RE: Kinesio Headquarters

Grading and Drainage Plan

Engineer's Stamp Date 11-30-2015 (File: D17D103)

GRADING AND DRAINAGE PLAN

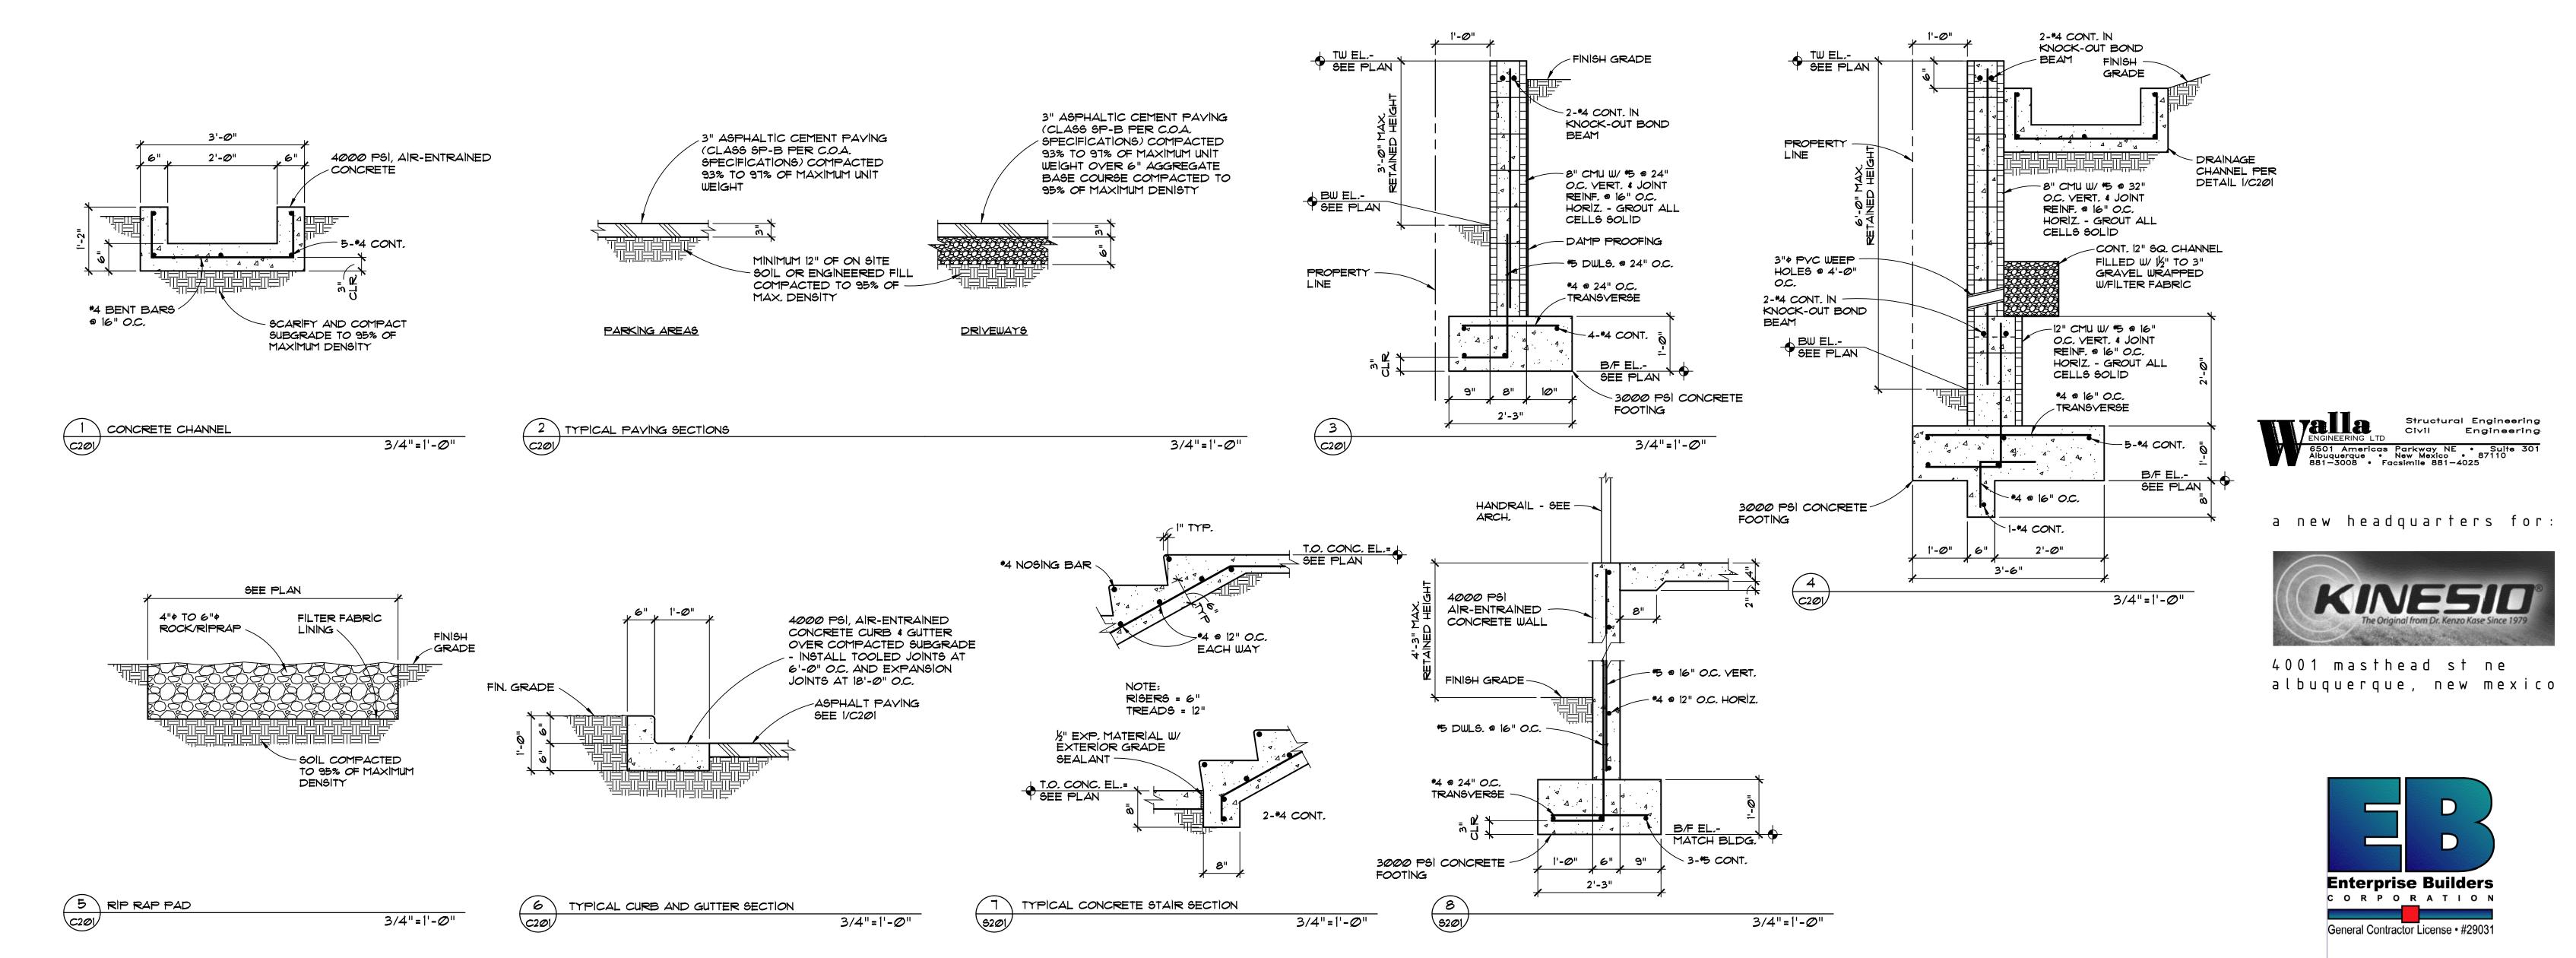
We understand that the license agreement with AMAFCA is in progress for the drainage outlet onto their Right of Way. Concurrence that the license agreement is completed (or that it will be completed) will be needed. Provide a calculation of the capacity of the outlet opening/structure to show that the peak flow of the pond is controlled.

2. Provide a capacity vs required flow calculation for the rundown just downstream of the last roof drain to show that the peak flow is contained in the structure.

3. Beginning January 15th, 2016, the City will amend the standard city street section (std drawing 2405A and B) to include a depressed landscape buffer between the sidewalk and back of curb. We request that you consider implementing this detail for the landscape buffer on the Masthead Street frontage.
